MIL-PRF-22710/24A
AMENDMENT 2
18 February 1983
SUPERSEDING
AMENDMENT 1
29 July 1980

PERFORMANCE SPECIFICATION SHEET

SWITCHES, ROTARY (PRINTED CIRCUIT)
(TOGGLE, BIDIRECTIONAL, SEALED, ILLUMINATED OR NONILLUMINATED),
STYLE SRPC24

FIGURE 2. Panel seal gasket.

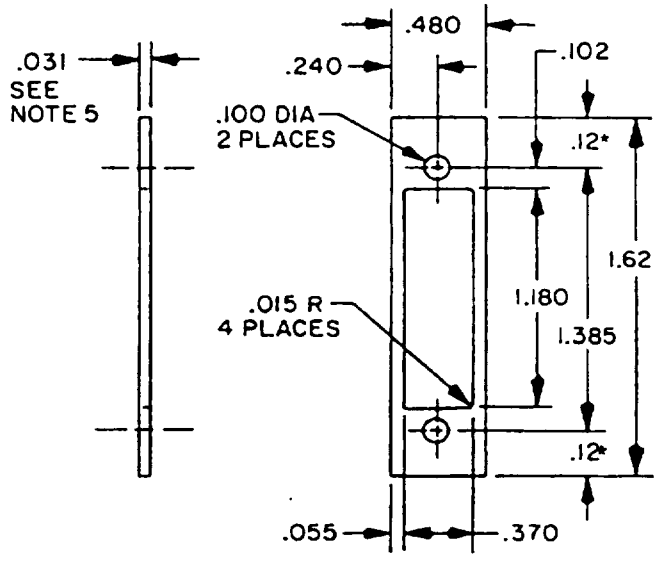
FIGURE 2; Delete and substitute:

NOTES:
1. Dimensions are in inches.
2. Metric equivalents are given for general information only and are based upon 1.00 inch = 25.4 mm.
3. Unless otherwise specified, tolerances are ±.005 (.13 mm) for three place decimals and ±.02 (.5 mm) for two place decimals.
4. Panel seal material shall be neoprene rubber for non RFI unit and silicone rubber (per ZZ-R-765) for RFI unit.
5. For the RFI shielded switch, material thickness of the conductive panel seal gasket shall be .062 ±.015 (1.57 ±.38).
